**PLANNING COMMISSION STAFF REPORT
MAJOR SUBDIVISION SMP2022 0001
HEARING DATE: DECEMBER 13, 2022**

PROPOSAL: Applicant requests Preliminary Plat Approval for a subdivision of one 19.71 acre lot into three parent lots: 7.5 acres, 6.8 acres, and 4 acres. Subdivision includes dedication of right-of-way.

PLAT OF RIDGEVIEW SUBDIVISION A SUBDIVISION OF RECORD DOCUMENT NO. 2022-001111-0 WITHIN U.S. SURVEY NO. 1568 JUNEAU RECORDING DISTRICT CITY & BOROUGH OF JUNEAU, ALASKA	
RECORDED AT THE STATE RECORDER'S OFFICE AT ANCHORAGE	
OWNER: ROOFTOP PROPERTIES, LLC. 956 NORTH 200 EAST SPANISH FORK, UT, 84660	SURVEYOR: JW BEAN, INC. PROFESSIONAL SURVEYOR 1070 ARCTIC CIRCLE JUNEAU, ALASKA 99801 (907) 789-0590
CASE NUMBER: PAC2022-0023	PARCEL NUMBER: 5B1410110010
DATE: 12-01-2022	SCALE: 1"=100' SHEET 1 OF 3

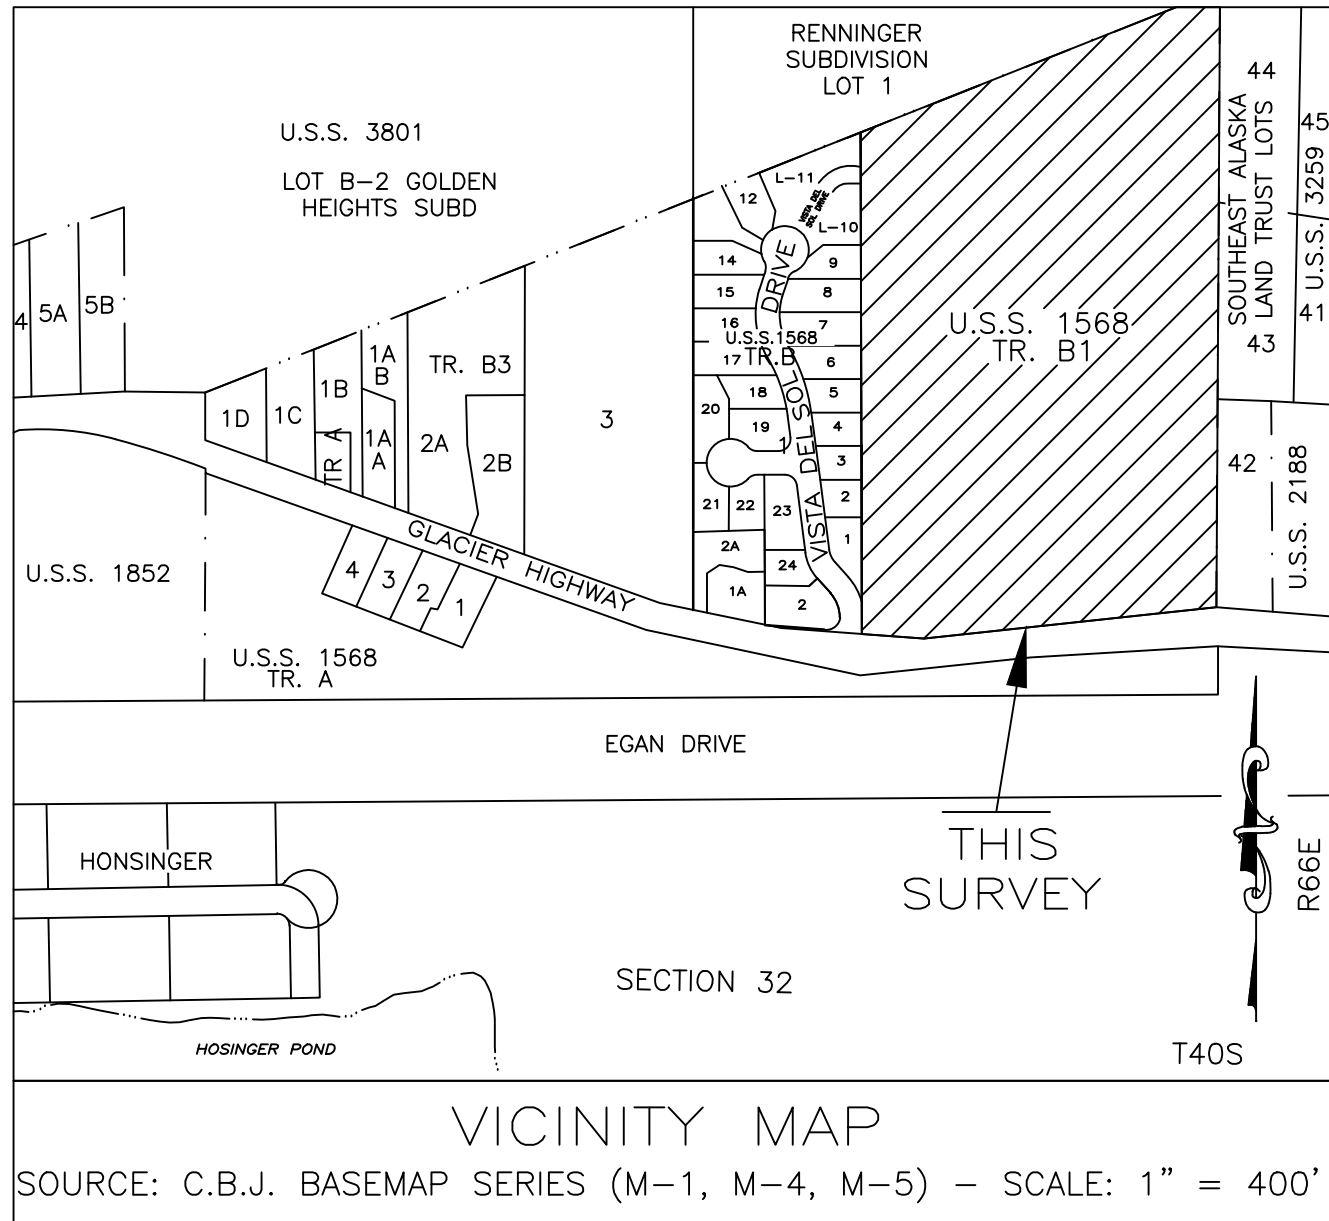
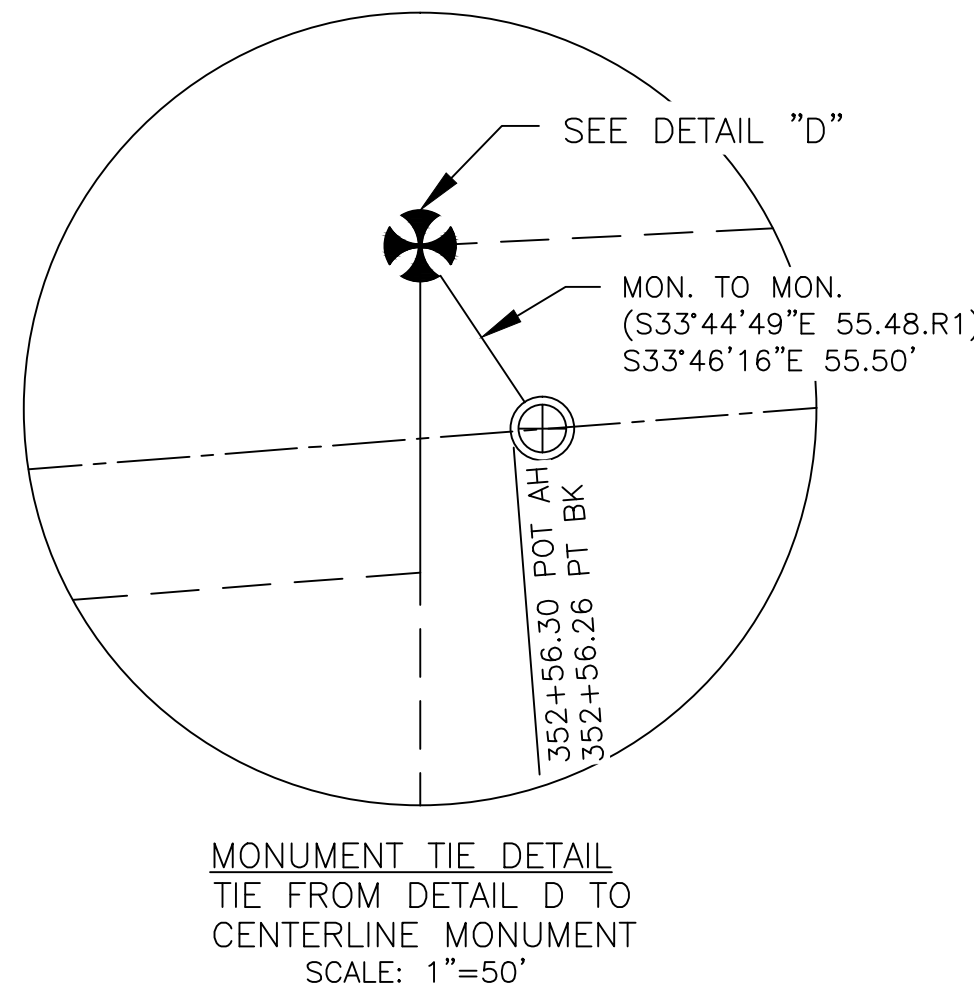
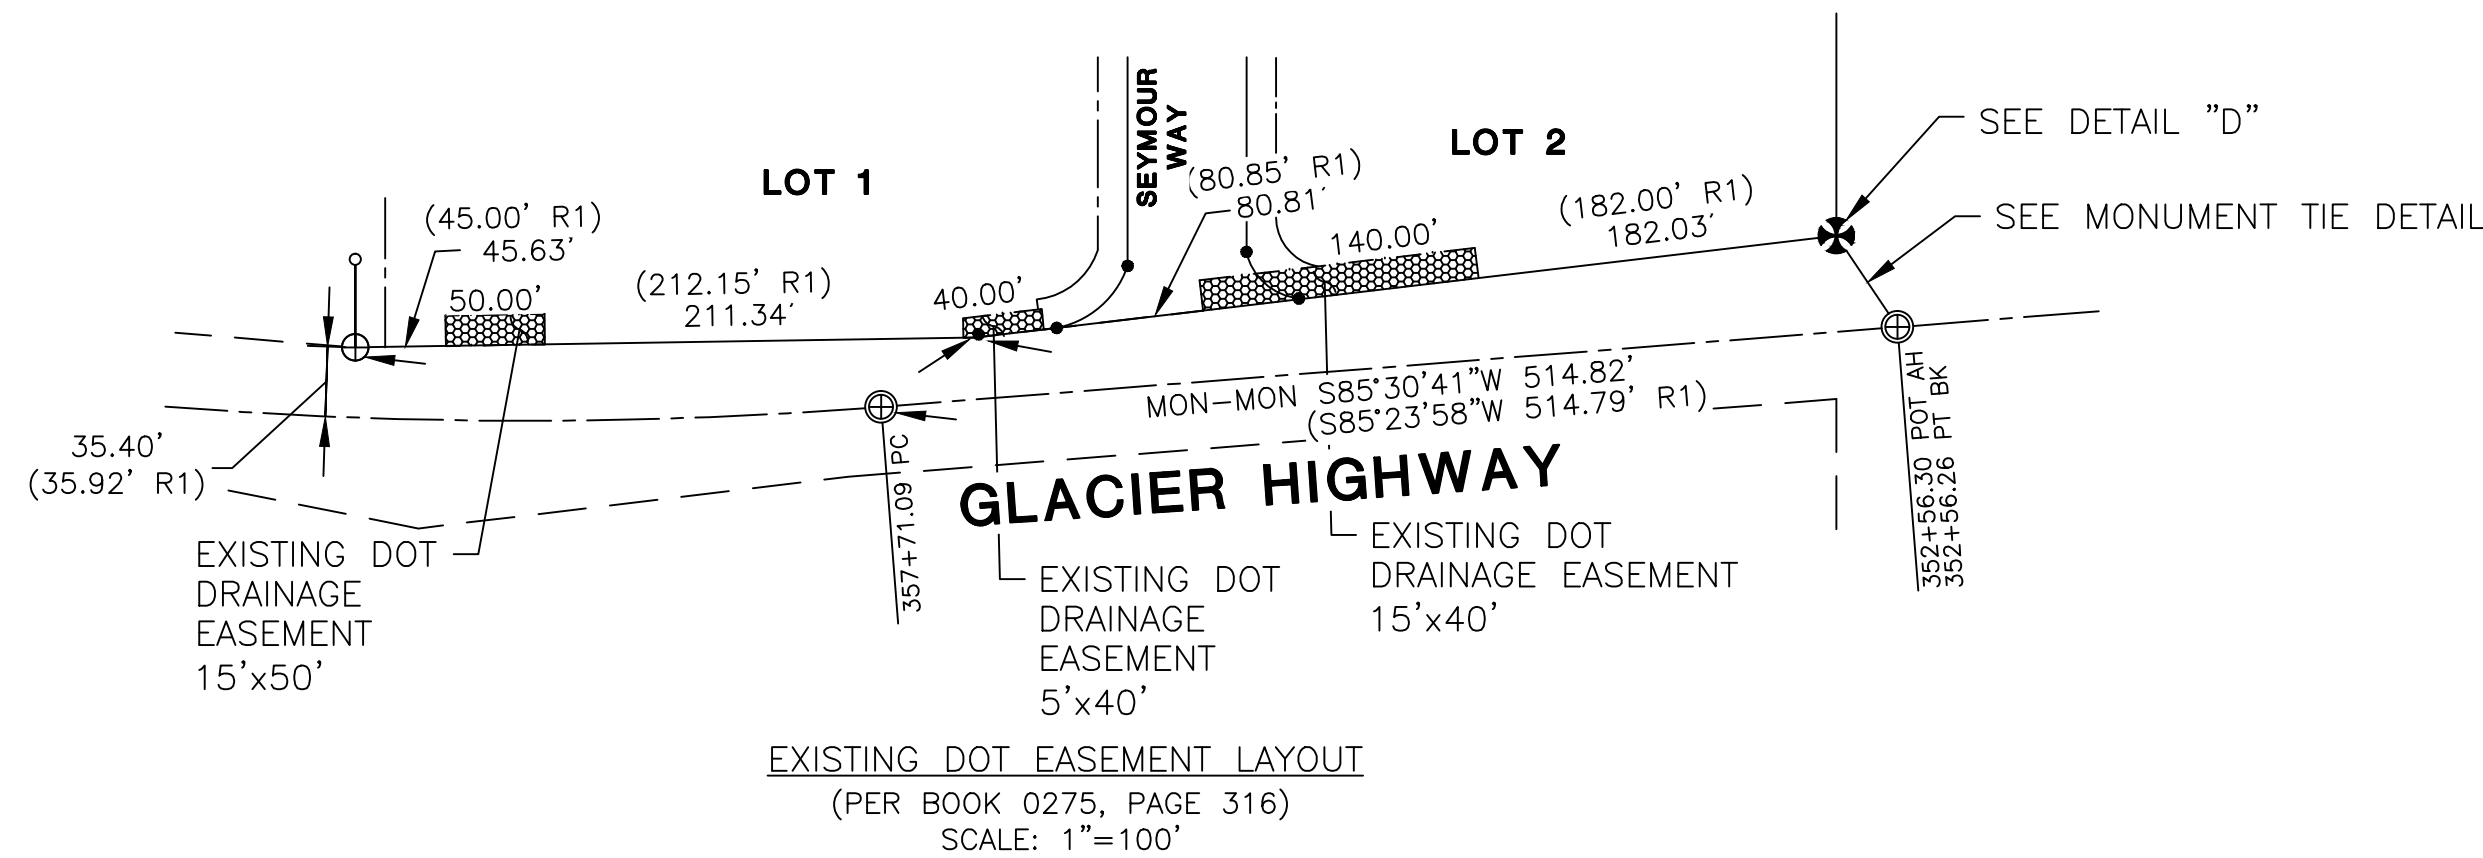
Condition: Prior to final plat approval, the plat will be revised to provide an emergency turnaround at the termination of Phase 1 at a minimum.

1. Prior to final plat approval, the plat will be revised to provide an emergency turnaround at the termination of Phase 1 at a minimum.

From: Dan Jager
To: Alec Venechuk; David Peterson
Subject: RE: SMP22-01 - Hammerhead v Cul-de-sac
Date: Tuesday, November 22, 2022 3:21:10 PM

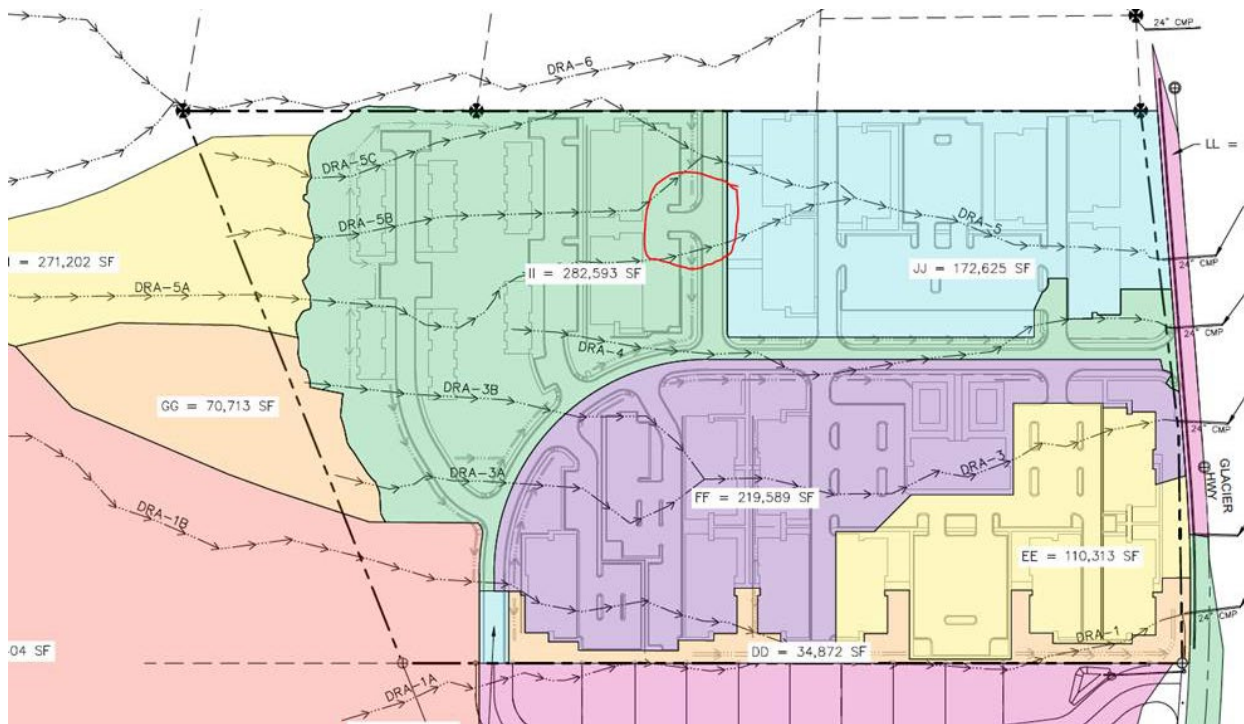
It looks like a hammerhead turn around might be best for this.
